MESHESAT-1357, stream a1mech, 29 Sep 2026. Case frame: X east, Y toward the hinge (back) wall, Z up from the base floor, lid closed. mm. Prototype design, AI review: nothing built, bought or fitted; analytical success is not physical verification.

MeshSat field kit V2, Option A(i) lid pack: sheet A1-2 sections: the module under the ceiling over the face, at the worst room

MeshSat field kit V2, Option A(i) lid pack: sheet A1-3 the arrangements that fit, and the owner decision

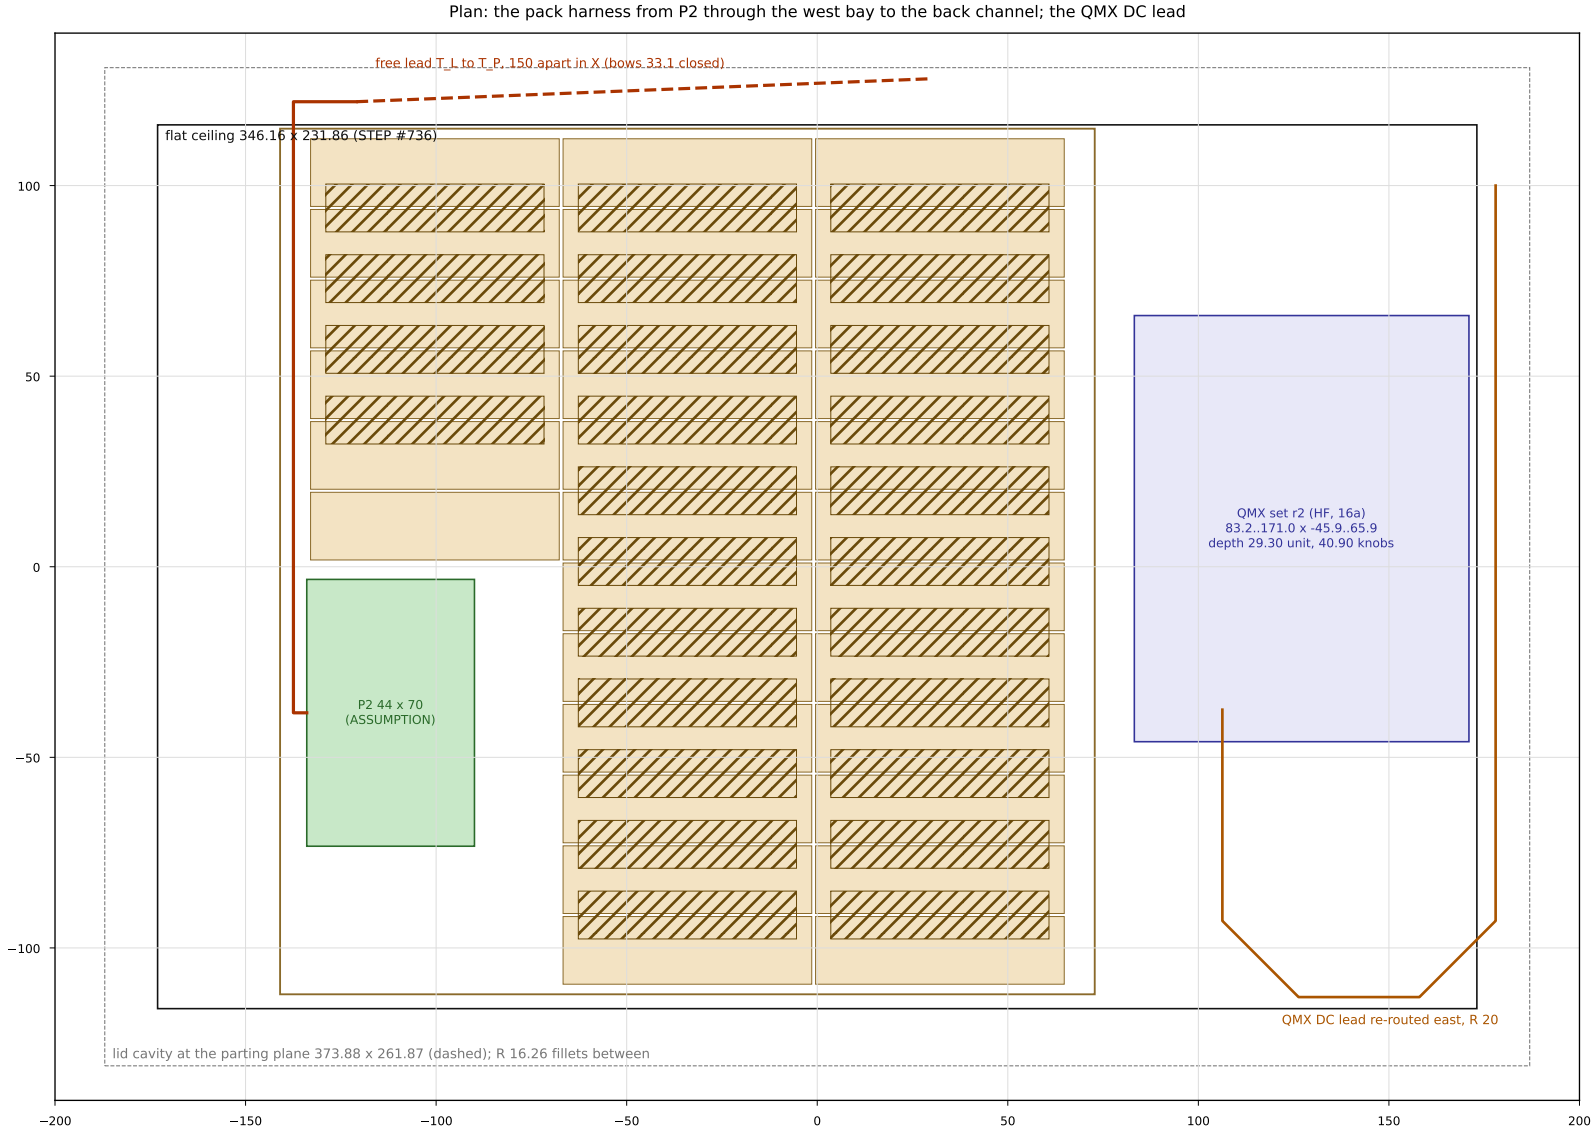
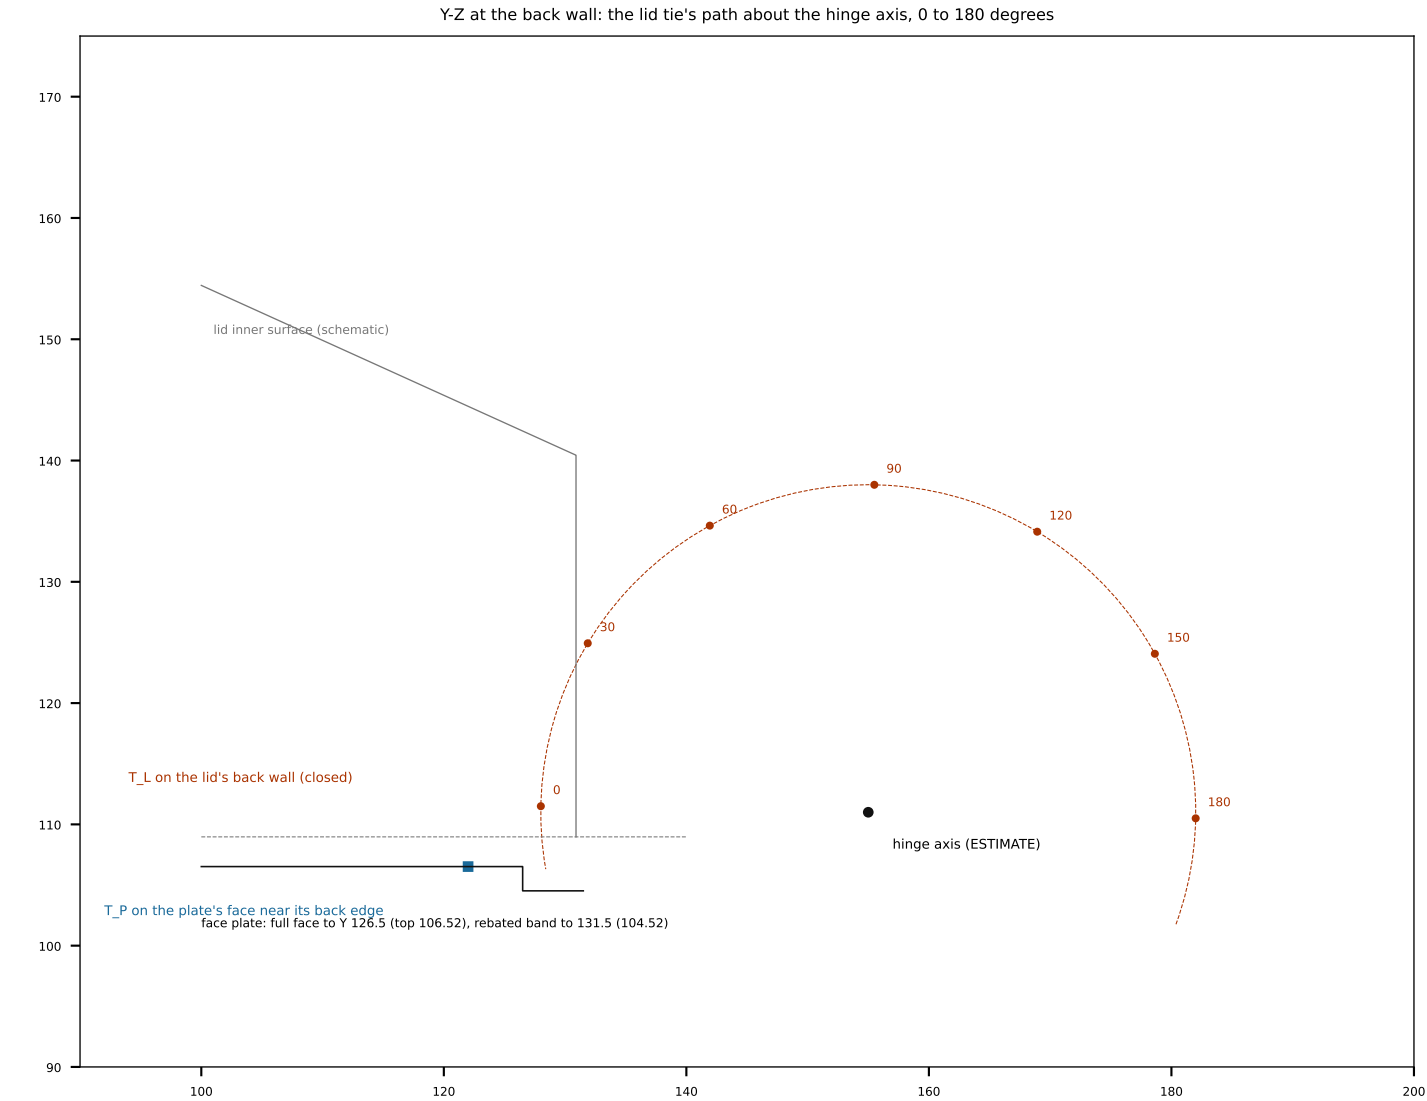
48 cells (4S12P) in the lid with BOTH the QMX HF set (16a) and the tablet bracket (16d): DOES NOT FIT. At the worst room the lid holds 39 places with both, 4S9P, 4S15P in all (the check's B1).

1. HF kept, tablet bracket out of the lid: 56 places (4S14P); the tablet goes out of the case.
2. 8 inch tablet kept, HF (QMX) out of the lid: 61 places (4S15P); HF inside (16a) is lost: the base has no volume for the QMX set
3. Both kept, lid pack 4S9P (4S15P in all): not Option A(i). The coordinator's two-pack run (Sept. reference day, 200 W stage): lid at its 13.23 C basis NOT MET at 400, 650, 1000 Wp; lid at +20 C NOT MET at 400 Wp, met at 650 (2.0 Wh left) and 1000 Wp (29.4 Wh left)

10 inch tablet: only with HF out: 48 places (4S12P). Both out: 77 places (4S19P).

Session's recommendation (engineering view only): option 1, which keeps a radio bearer and gives 8 spare places; the tablet works from outside the case on the kit's WiFi and USB-C outlet.

D-01 already defers HF, the tablet bracket and a second pack from prototype 1: Option A(i) reopens D-01 whichever option is taken.

MeshSat field kit V2, Option A(i) lid pack: sheet A1-5 mass and open-lid stability

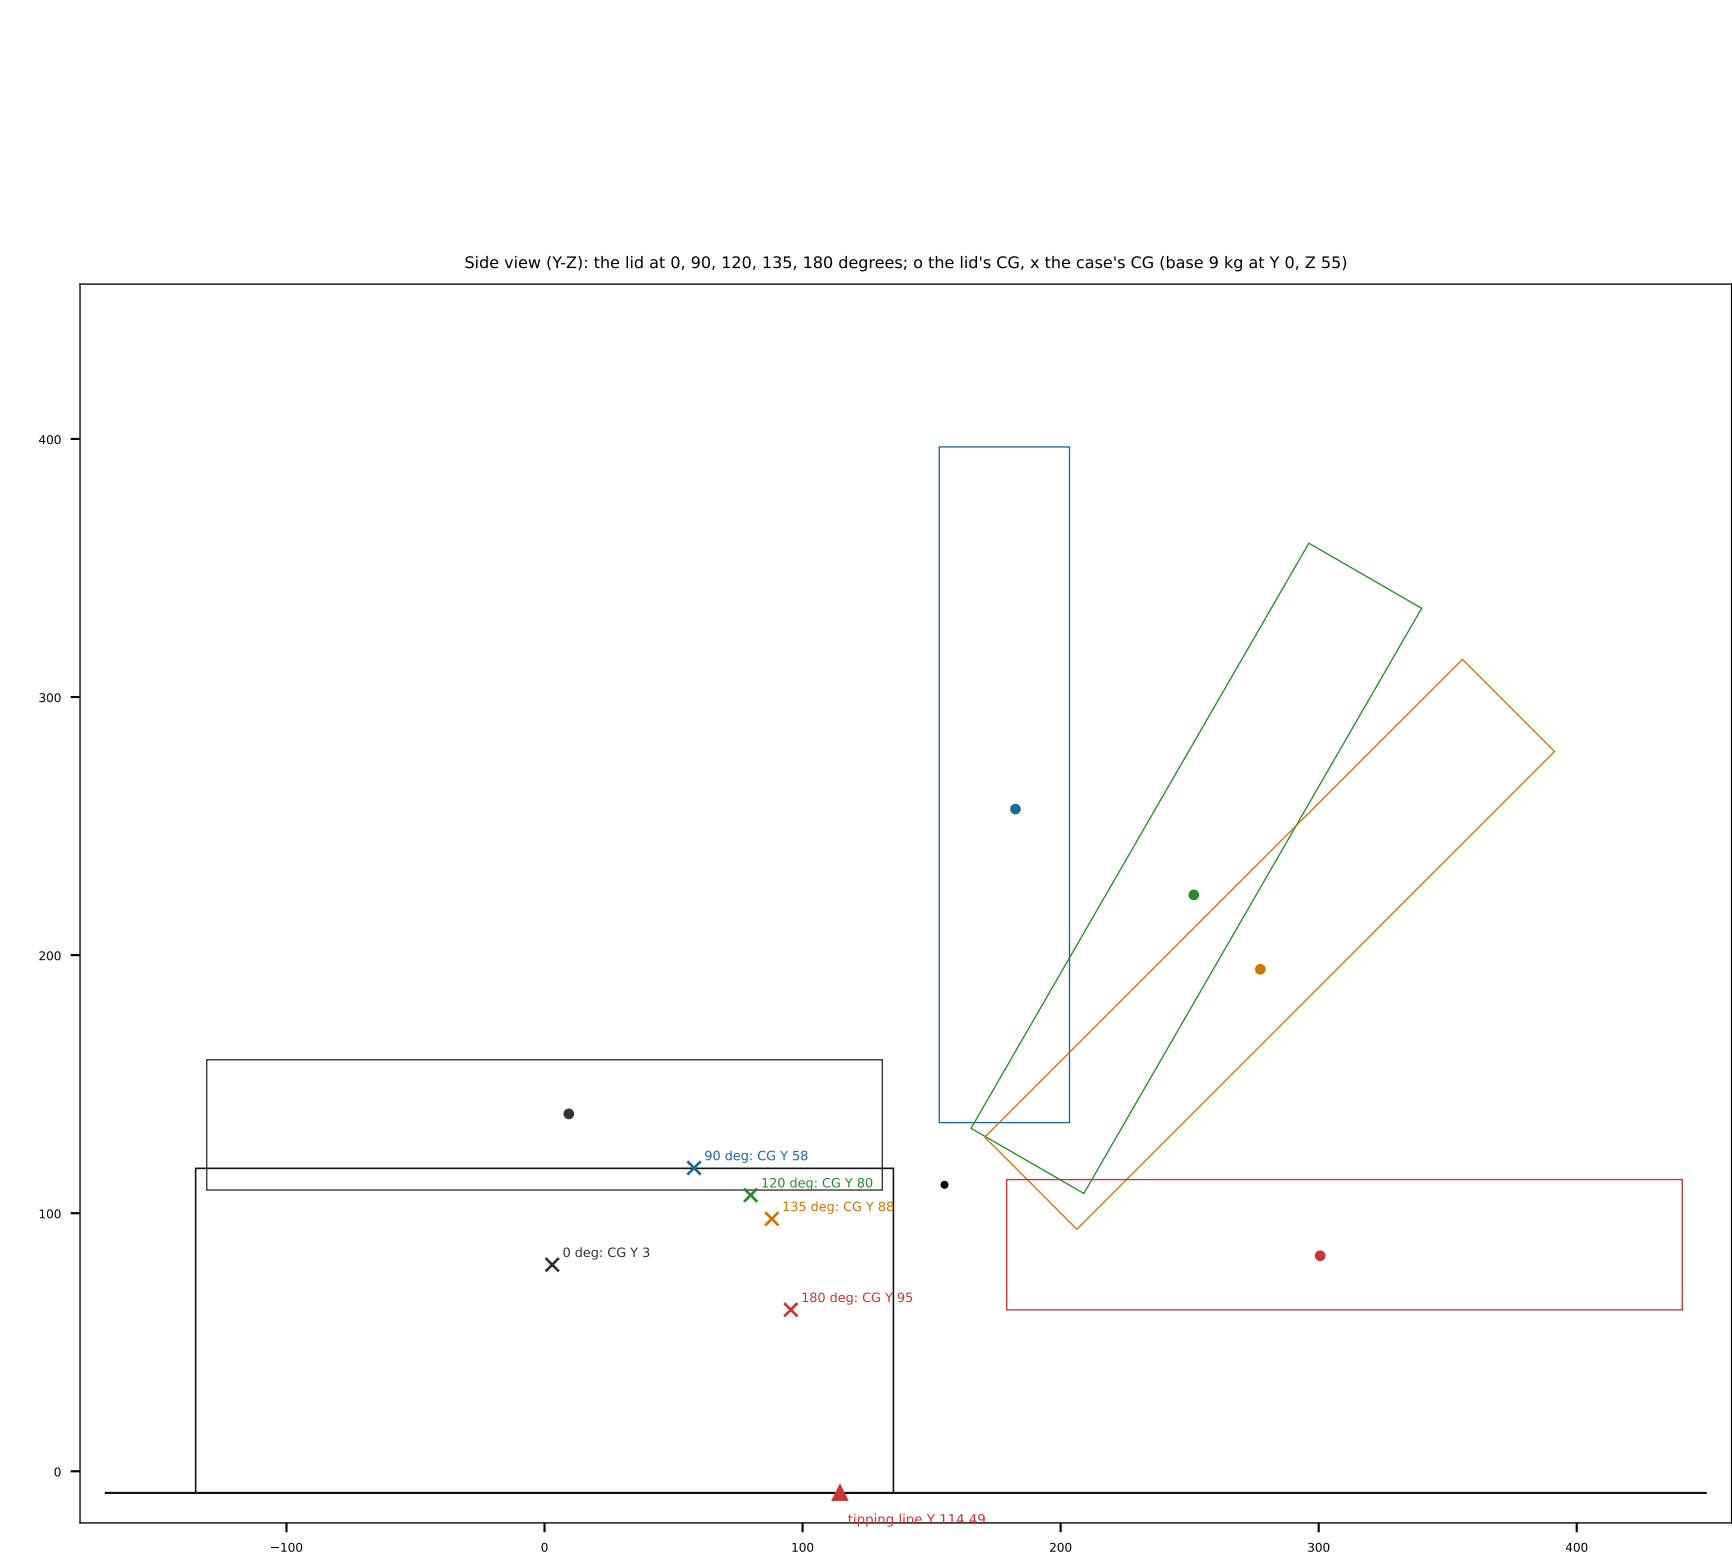
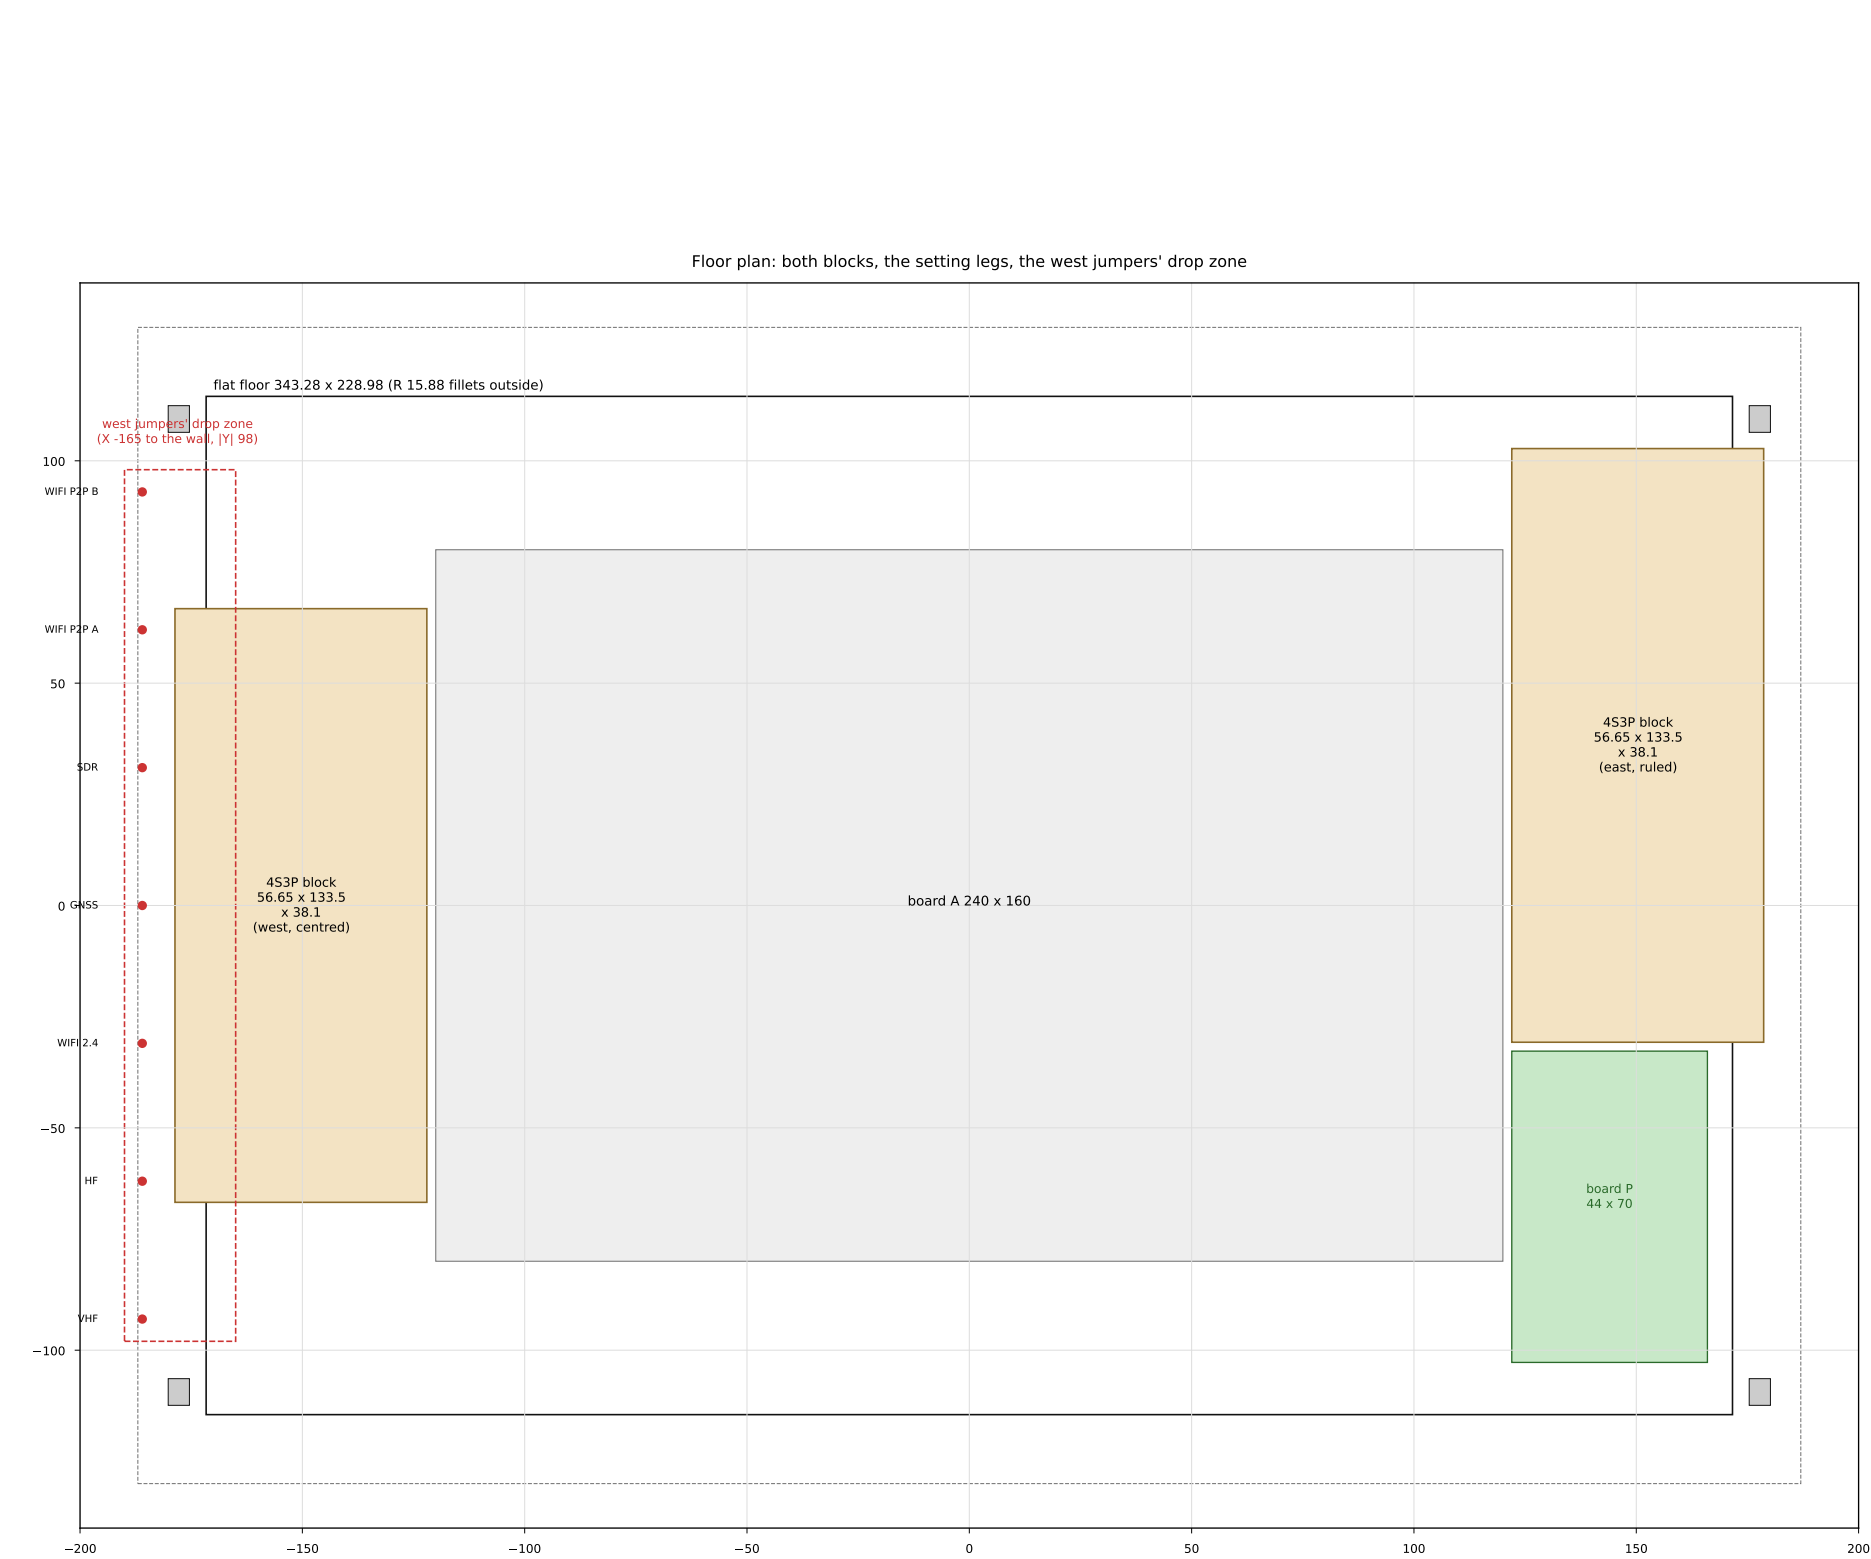
WORST OVER THE SWEEP (base 7..14 kg, CG Y -20..+20, Z 45..65, hinge axis Y 147..163): critical back slope, deg

lid open	B	A
90	14.9	16.0
100	11.6	12.7
110	8.4	9.6
120	5.4	6.6
135	1.4	2.6
150	-2.1	-0.7 (tips on level ground)
180	-4.8	-2.9 (tips on level ground)

VERDICT: stands on level ground to 120 degrees of opening in every swept case; a light base tips from 135. FIX (SESSION, reversible): a lid stay stopping the lid at 100 degrees (webbing strap at X -179, a tab bonded to the lid's west end wall, a tab under the plate's 6-32 at Y 75.95; 56 to 63 N static; about EUR 10). With it: back slope 9.5 deg (B), 7.0 (C) at the worst of the full sweep, 3.6 (B) with the feet inboard; a backward push of 9 to 13 N at the QMX's height tips the lightest case (lid_pack_a1.out section 4).

The stop angle, the hinge axis and the case's CG are read on the mock-up (T-A1-3); Peli states no load for its hinges (T-A1-4).
